SUNDRY NOTICES AND REPORTS ON WELLS
Do not use this form for proposals to drill or to re-enter an abandoned well. Use form 3160-3 (APD) for such proposals.

Prohibition Federal Unit 2 SWD
1980 FSL 2080 FWL
K-11-225-32e
Lea NM

Permanent Abandonment of Federal Wells
Conditions of Approval (LPC Habitat)

Prohibition Federal Unit 2 SWD
1980' FSL 2080' FWL
K-11-225-32e
Loc NM

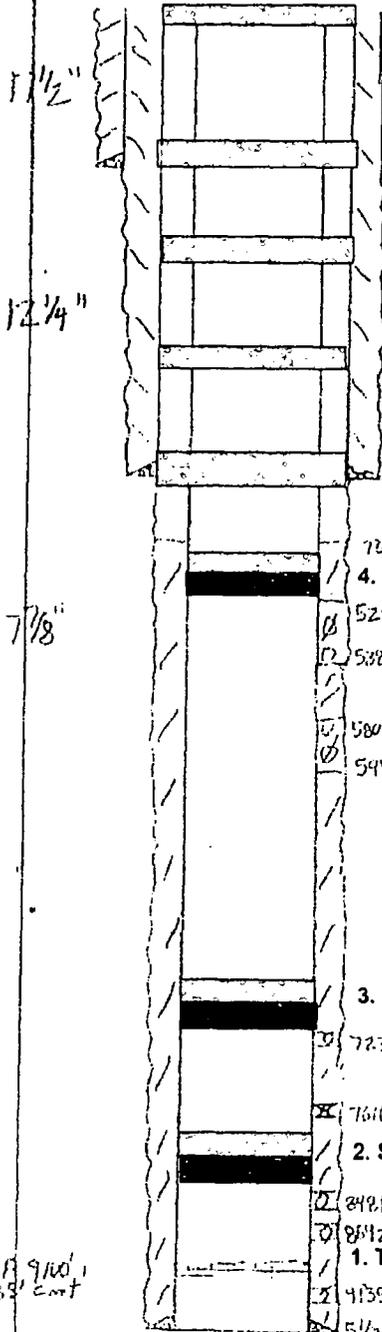
Below ground level dry hole marker required

** BLM REVISED **
